MONTGOMERY COUNTY HISTORIC PRESERVATION COMMISSION
STAFF REPORT

Address:	3 Quincy Street, Chevy Chase	Meeting Date:	7/10/2024
Resource:	Non-Contributing Resource Chevy Chase Village Historic District	Report Date:	7/3/2024
Applicant:	Thomas Jarrett & Martha Burke (Rich Ingram, Agent)	Public Notice:	6/26/2024
Review:	Historic Area Work Permit	Tax Credit:	n/a
Permit Number:	1073386	Staff:	Dan Bruechert
Proposal:	Tree Removal

HISTORIC AREA WORK PERMIT
TREE REMOVAL EXHIBIT
3 QUINCY STREET - LOT 34, BLOCK 61
PROPOSED LOTS 39 & 40
SEC. 2 CHEVY CHASE - 3 QUINCY ST.
BETHESDA (7th) ELECTION DISTRICT
MONTGOMERY COUNTY, MARYLAND

Figure 3: Site plan showing five trees proposed for removal outside the building envelope.

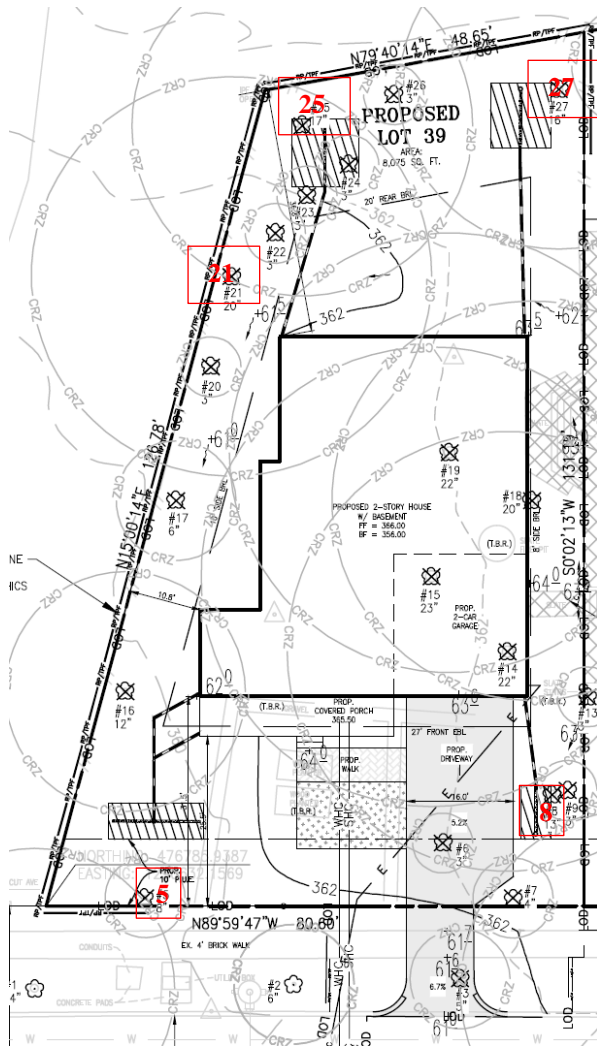
The identified limit of disturbance (LOD) is the entire lot. This is typical for development at this stage, and usually the LOD is reduced as plans are firmed up. Outside of the proposed building envelope, but within the identified LOD (see the site plan, below), the applicant seeks HPC approval to remove an additional 5 (five) trees.

Tree Number	Type	DBH (Diameter at Breast Height)
#5	Cherry Plum	8”
#8	Pin Oak	13”
#21	Catalpa	20”
#25	Willow	17”
#27	Willow	16”

Staff cannot find any justification to remove these trees. Staff finds eliminating these 5 (five) trees would negatively impact the open park-like setting of the historic district. While the site plan shows proposed drywells in the locations of trees #25 and #27, Staff finds the location of the drywells could be relocated so as to avoid these tree impacts and recommends the HPC not extend the HAWP approval to include these 5 (five) trees.

1. The approval of this HAWP is limited to the removal of trees #3, #6, #14, #15, #18, and #19.

Removing any other trees on the subject property will require a separate HAWP and additional justification;

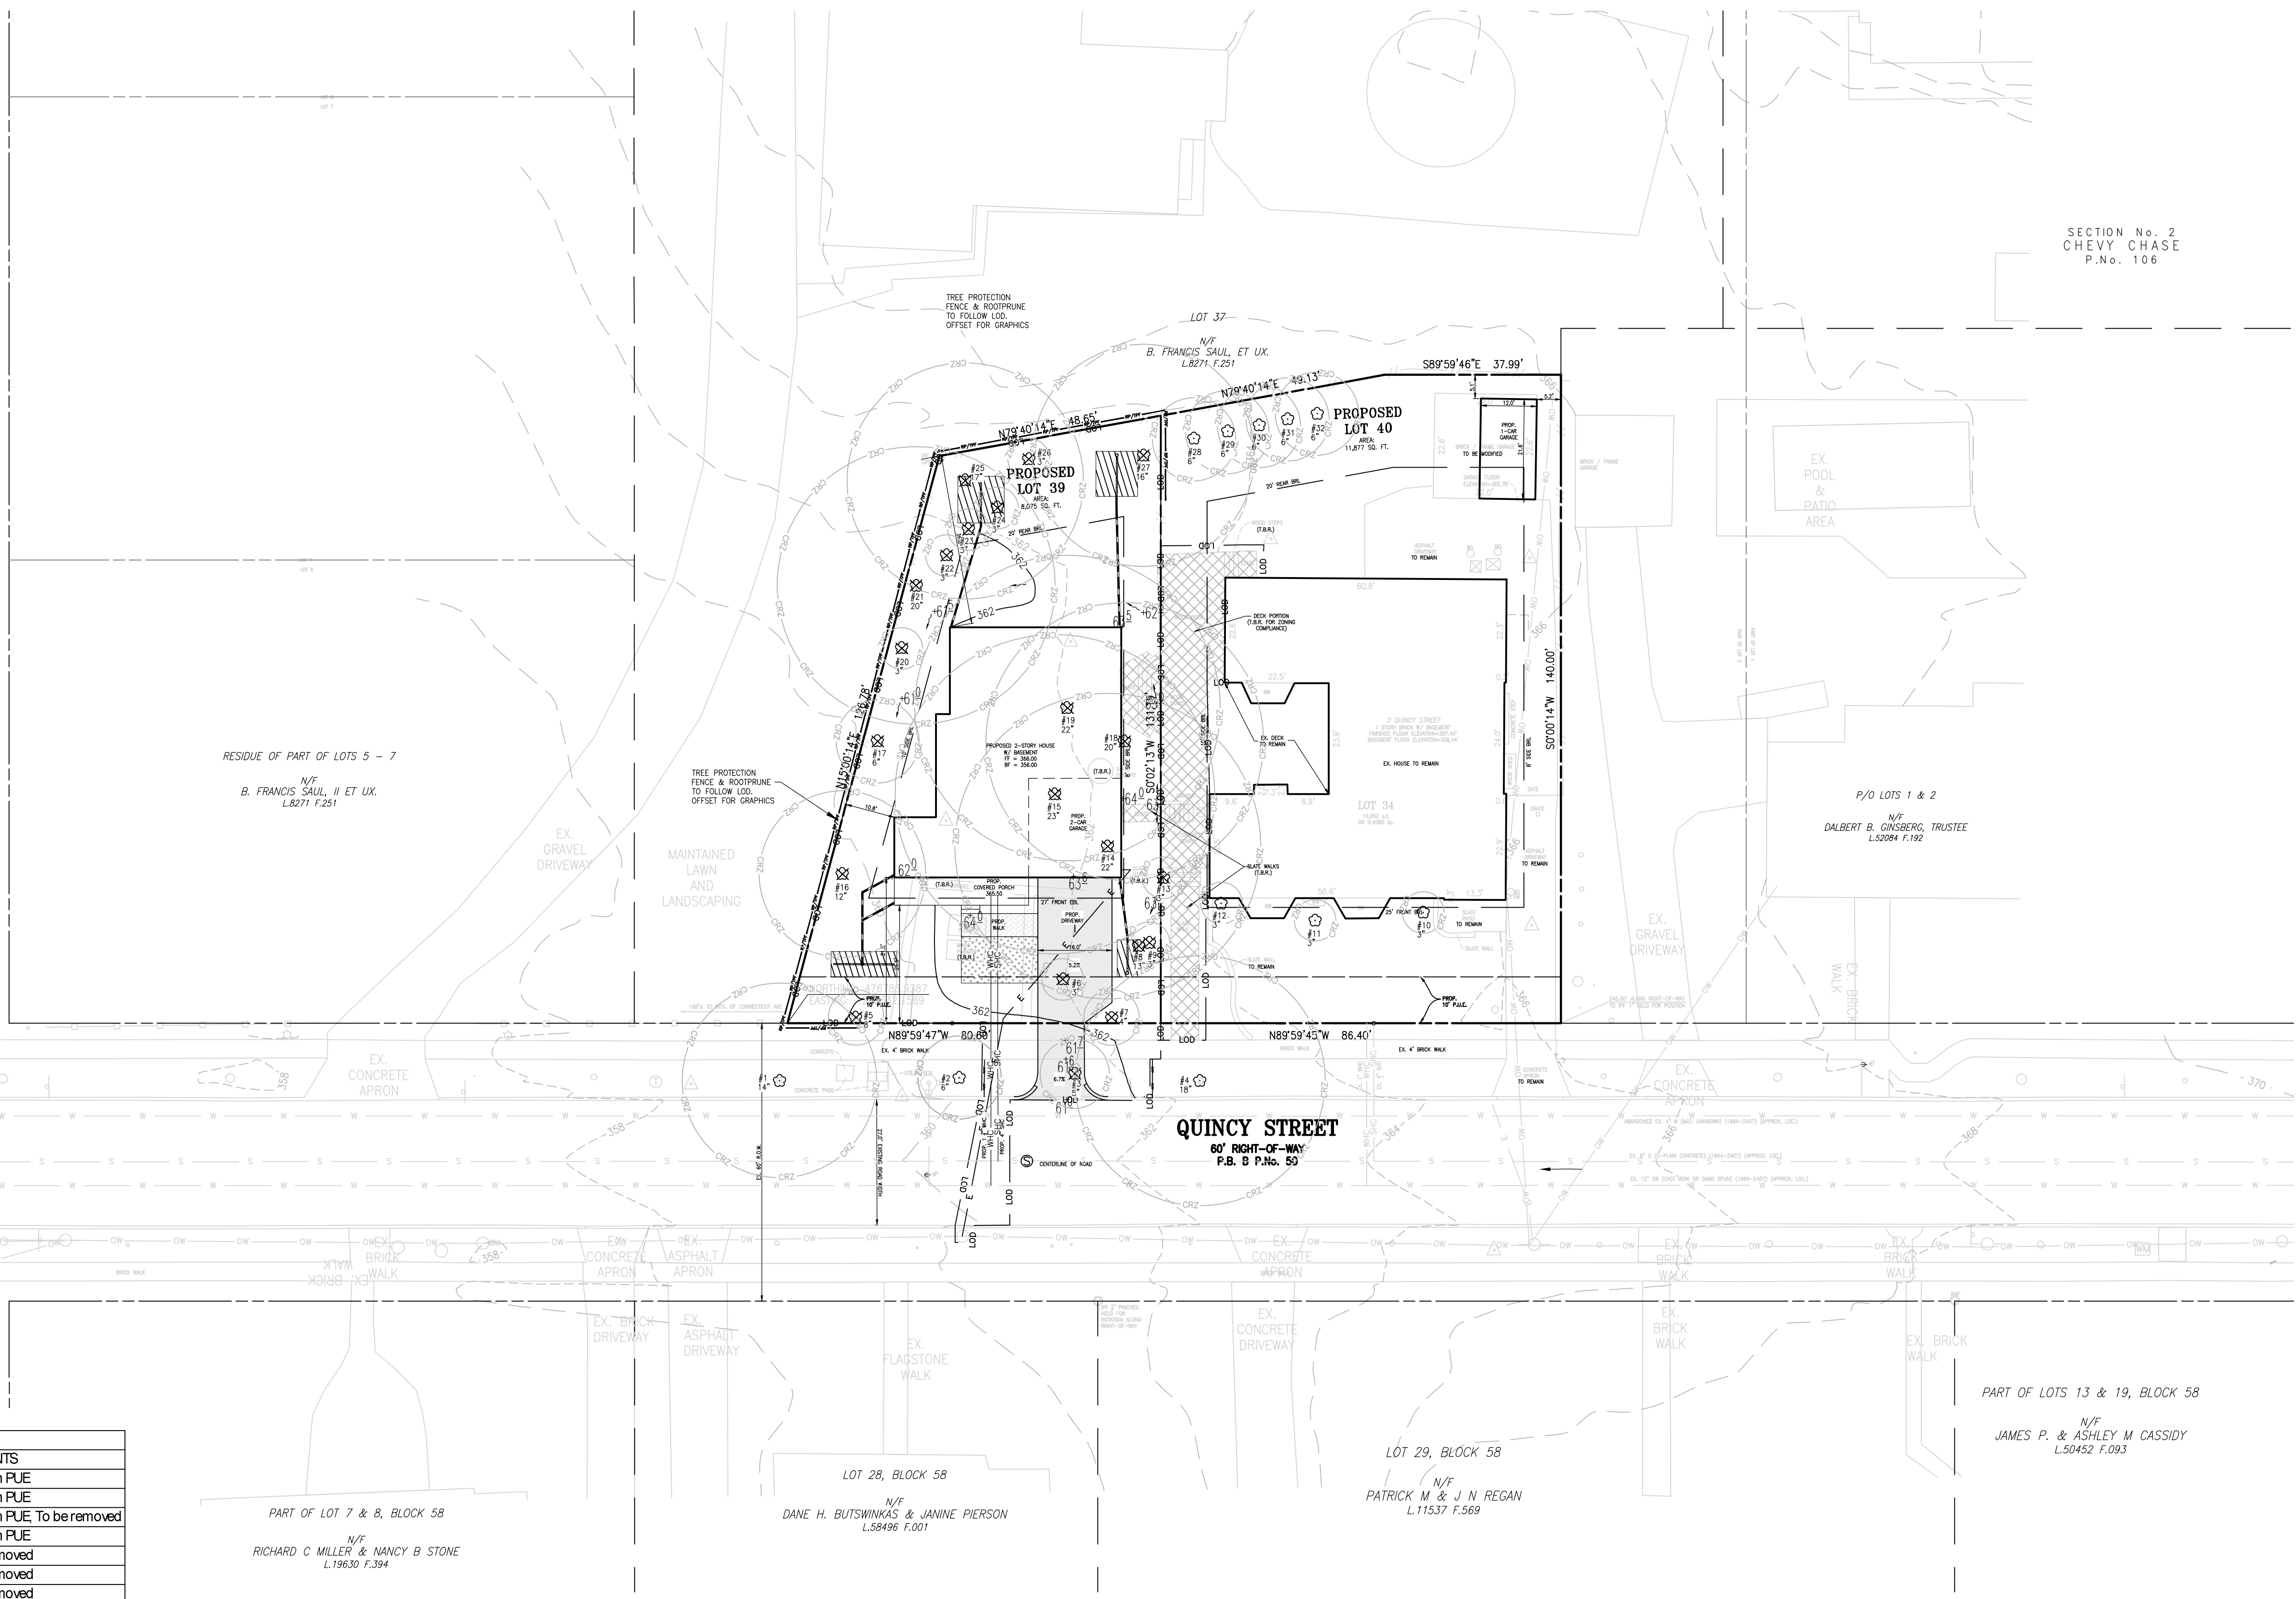
While the applicant has not completed an architectural design, a proposed building footprint and hardscaping footprint were developed. For the purposes of organization, Staff will divide its analysis between trees in the proposed development footprint and those outside of the proposed construction.

Tree Number	Type	DBH (Diameter at Breast Height)
#3	Laurel	5”
#6	Cedar	3”
#14	Red Maple	22”
#15	White Oak	23”
#18	Teak	20”
#19	Teak	22”

All of the identified trees are in ‘Good’ condition. Staff notes trees #3 and #6 are below the 6” d.b.h. (six-inch diameter at breast height) threshold requiring a HAWP. No further historic preservation review is necessary for these two trees (though a permit from Chevy Chase Village may be required prior to their removal). The remaining four trees are relatively large and are within the footprint of the proposed construction and in the middle of the buildable envelope. Staff finds that approving the removal of these trees will enable the applicant to begin to prepare the site for the additional work required to construct a

single-family house. Staff finds the overall character of the lot and surrounding district will not be irreparably harmed by the removal of the four trees subject to the HPC’s review and that the district’s open park-like setting will be maintained. Staff recommends the HPC approve the removal trees #14, #15, #18, and #19. Chevy Chase Village maintains its own Urban Forest Ordinance and Staff reminds the applicant that the ordinance may require additional plantings or paying a fee in lieu of planting.

The final four trees proposed for removal are north of the existing house at 3 Quincy St., and not on the newly created lot. They are identified in the specimen tree list, but are not identified as to be removed on the site plan. Those four trees are all Serviceberrys and are behind the existing house. Staff would support their removal, however, the discrepancy in the plans needs to be cleared up before proceeding. Staff finds the location of these trees coupled with their size makes them eligible to be reviewed and approved at the staff-level once this discrepancy has been rectified.

#28	Serviceberry	6"
#29	Serviceberry	6"
#31	Serviceberry	6"
#32	Serviceberry	6"

1. The approval of this HAWP is limited to the removal of trees #3, #6, #14, #15, #18, and #19. Removing any other trees on the subject property will require a separate HAWP and additional justification.
